Re: **The Parklands Village V2F1 – Site Plan and Plat - Response to Comments (2022-4054-00; 2022-3092-00)**

FIRST TECHNICAL REVIEW

PLANNING DEPARTMENT COMMENTS – DEBORAH BICKMIRE

LOT TYPICAL OVERALL MAP - N.T.S.

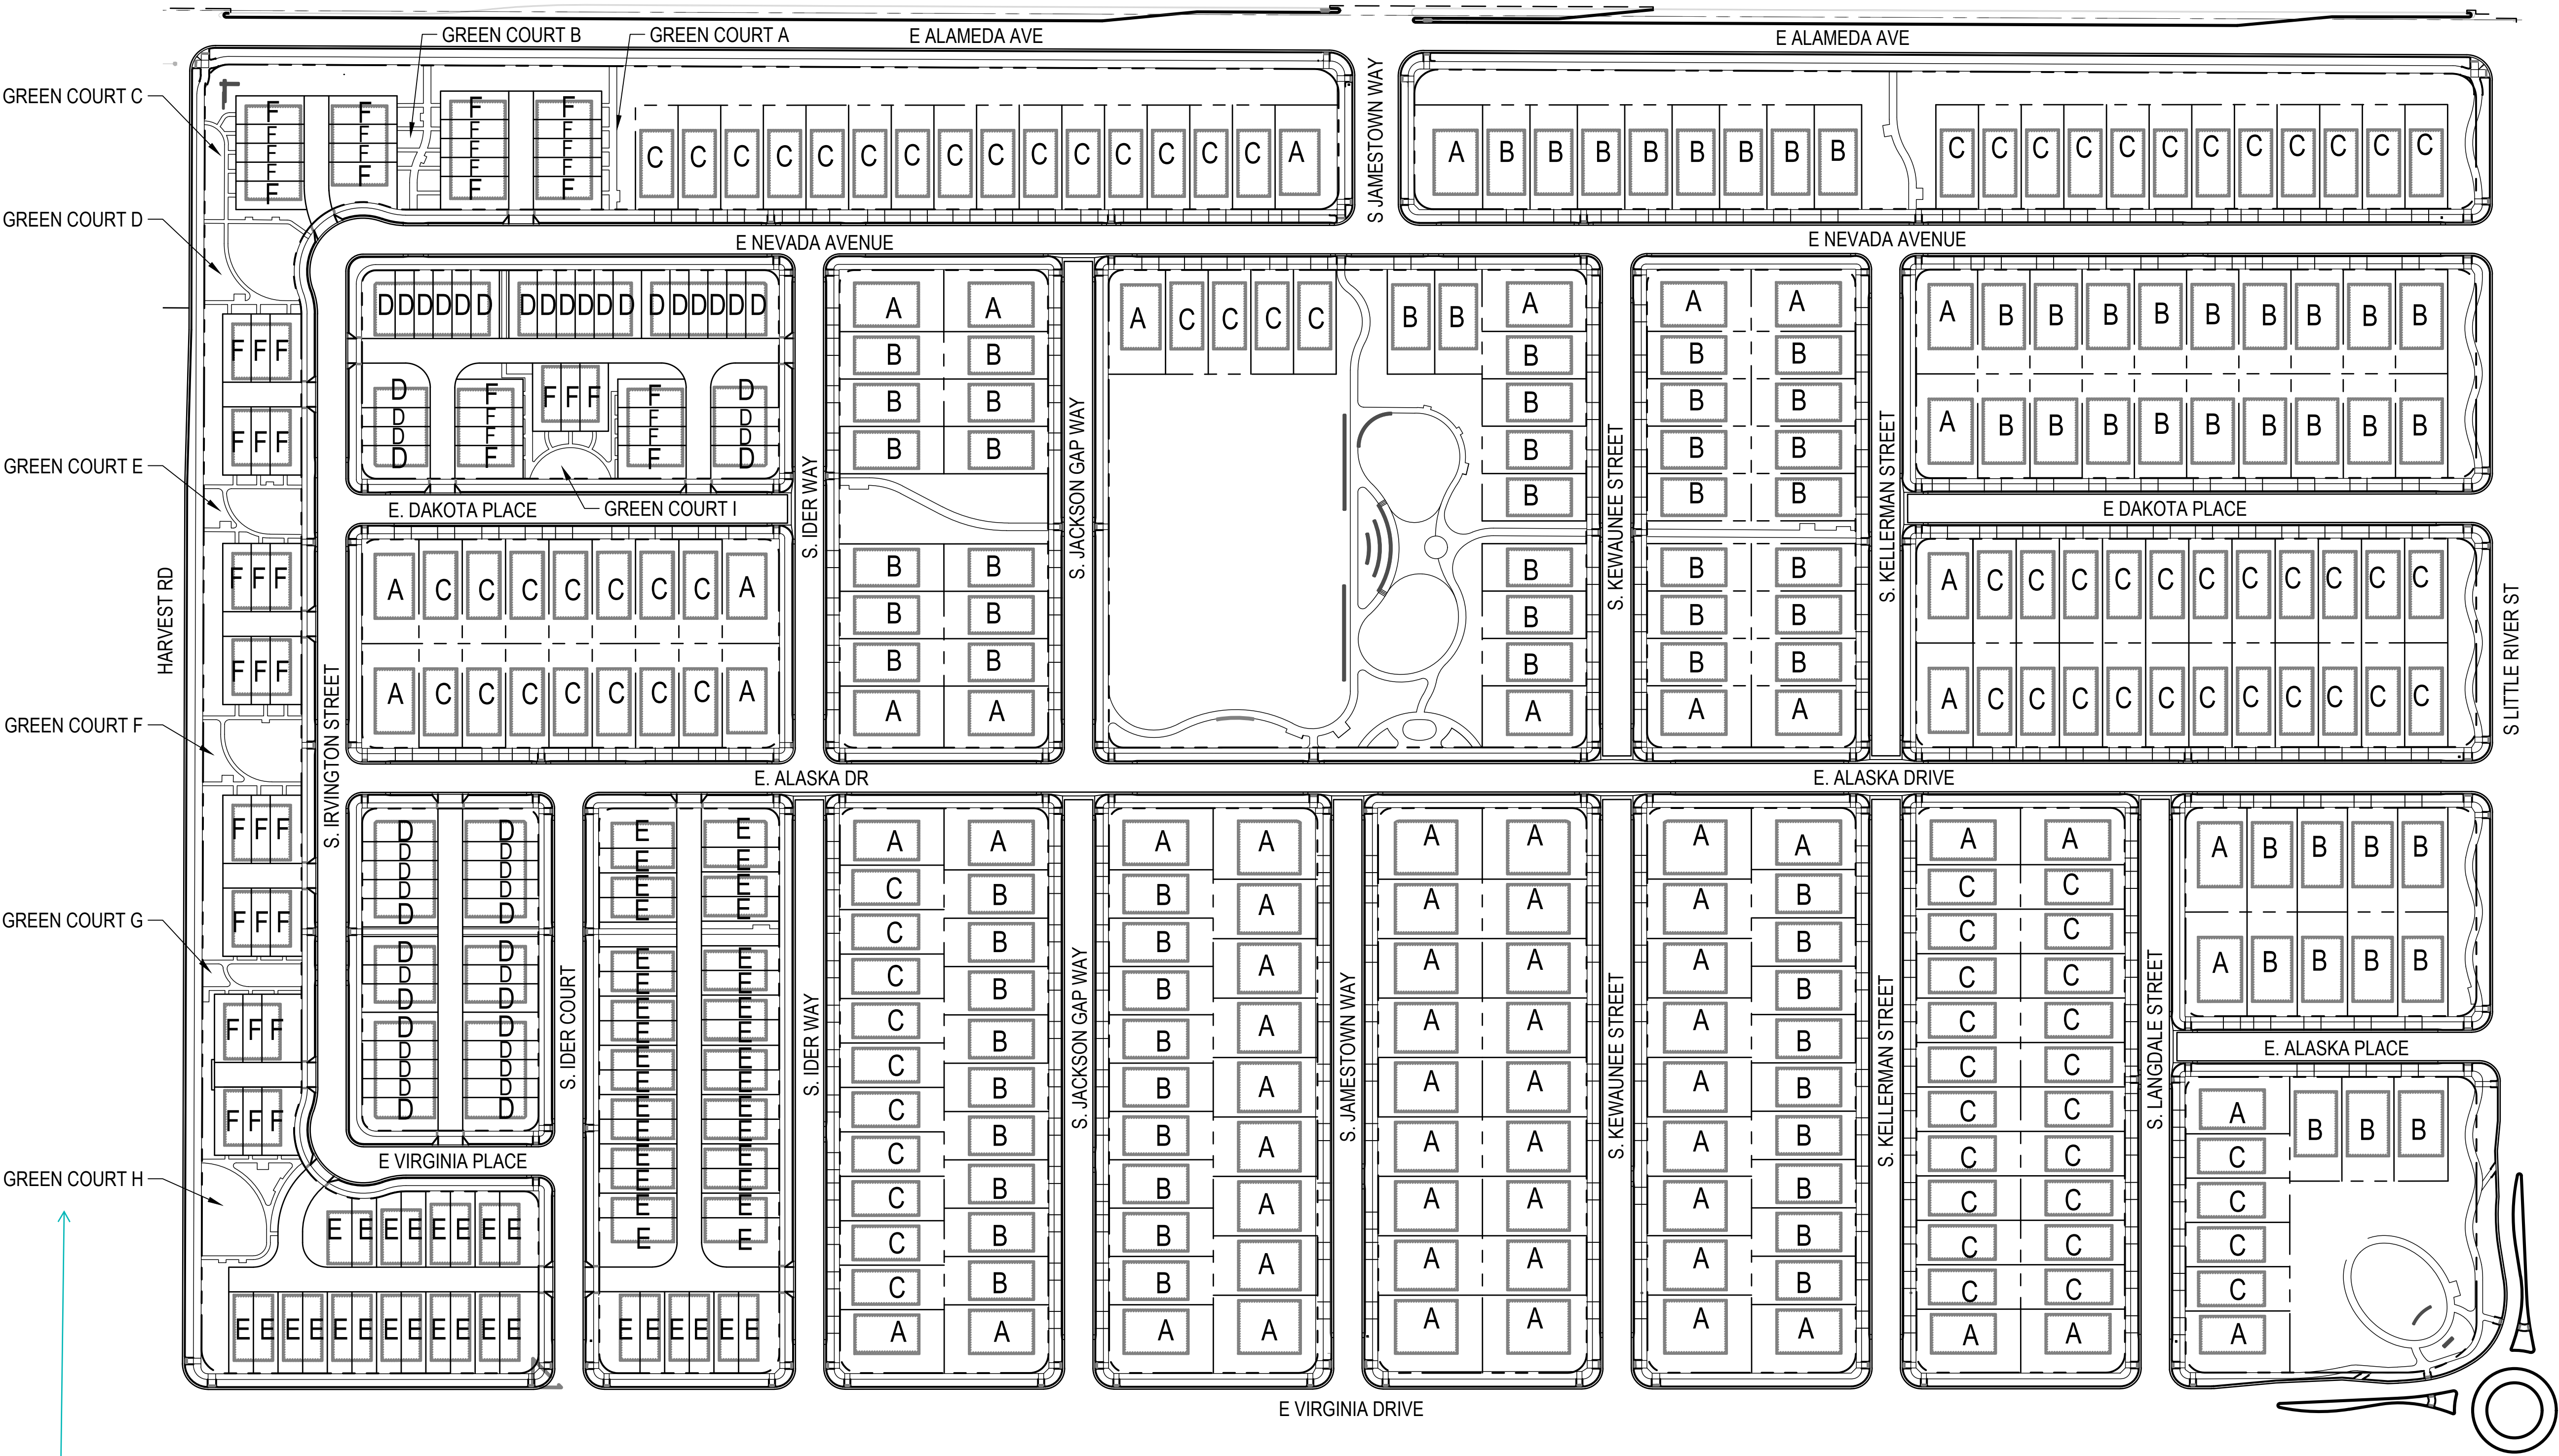
add tract labels to be consistent with the site plan and plat

match the summary on Sheet 6

Response: Tract labels have been added.

Response: Unit count matches the summary on sheet 6.

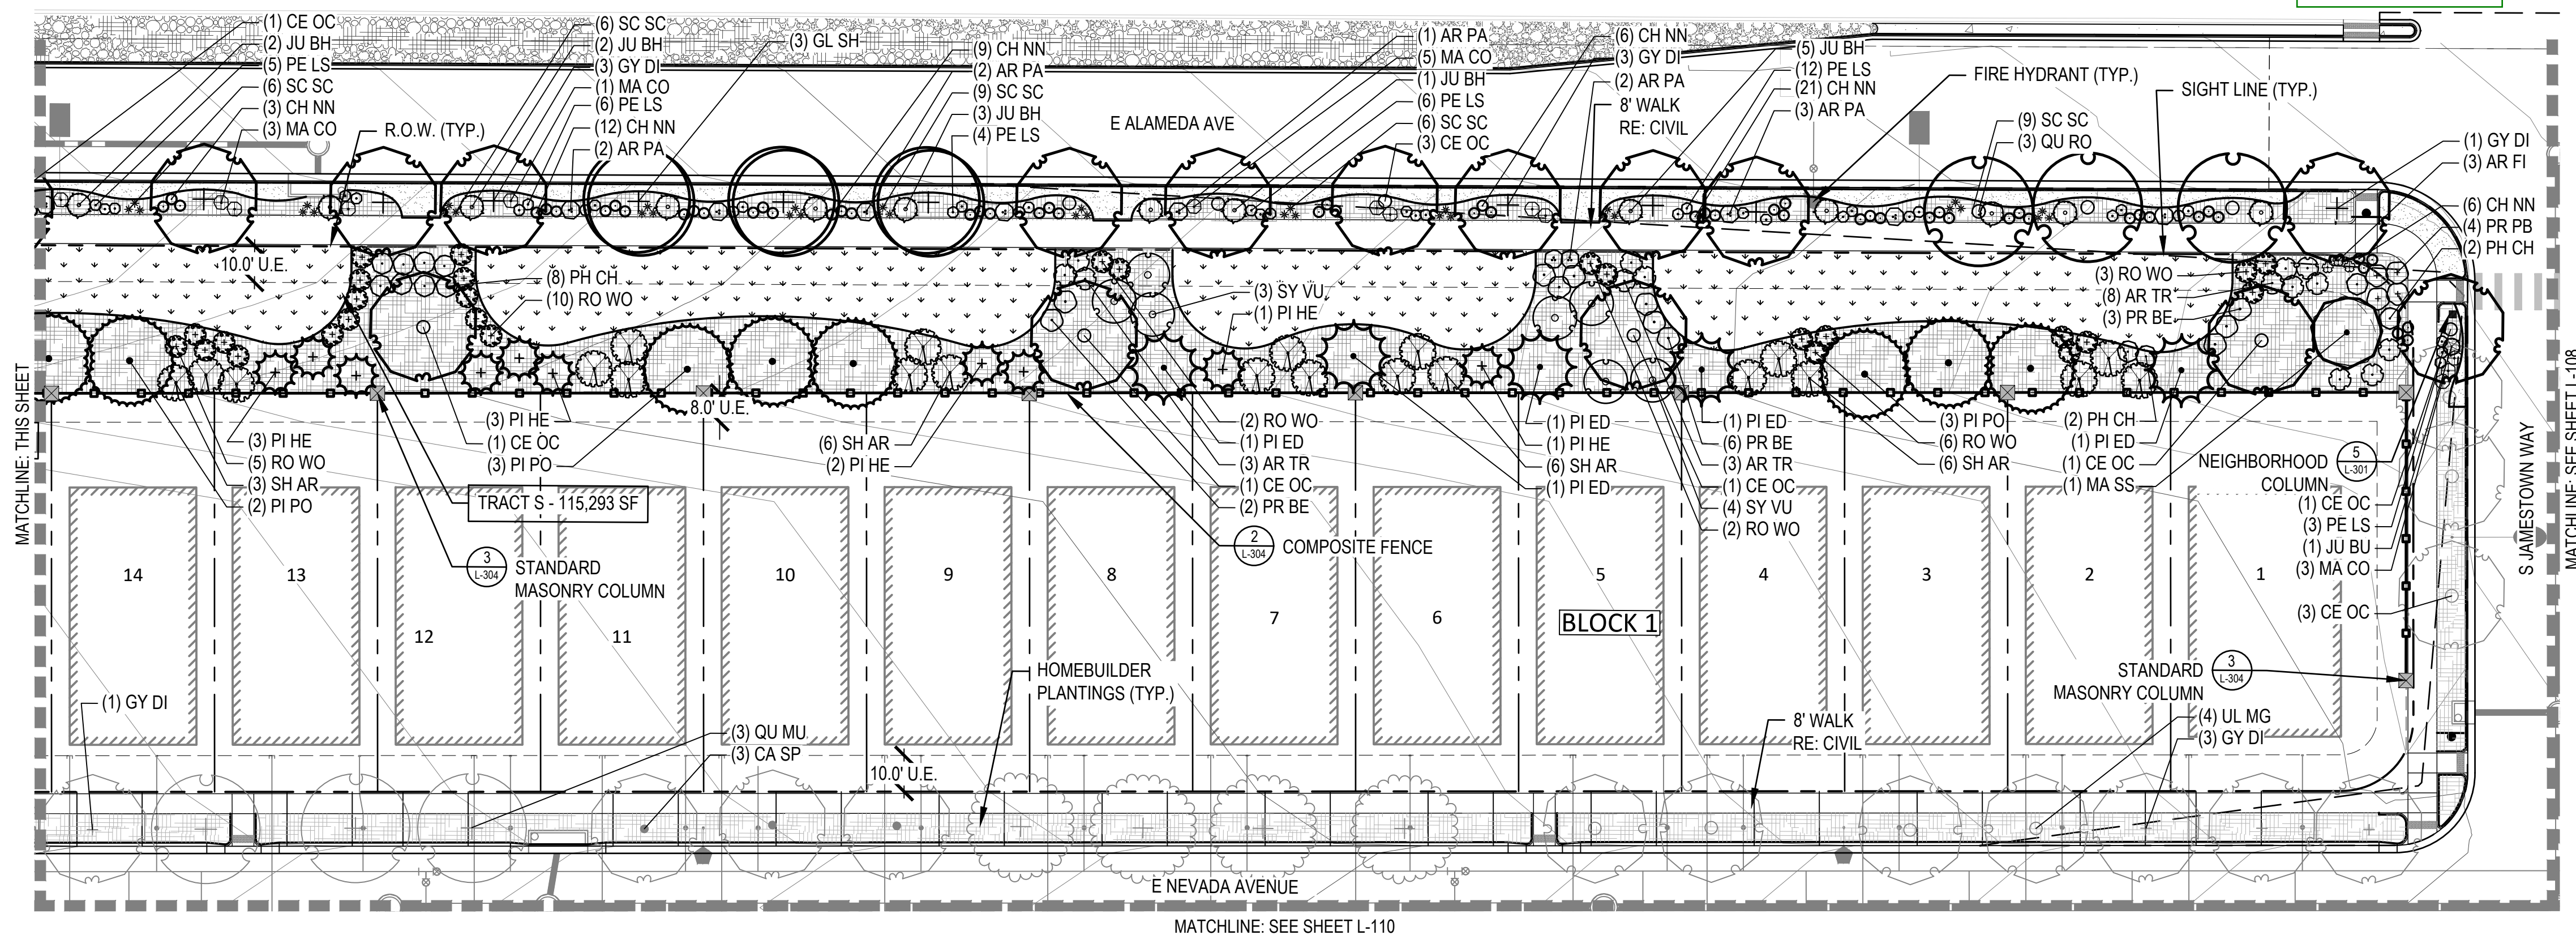
Include stop signs in the legend and on the plans.

If an ISP # exist for this side of the roadway, please provide the name and CN#.

On all sheets: show these trees darker for purposes of this drawing as they are being counted toward the street tree requirements.

Response: Applicable ISP / CN #'s have been added.
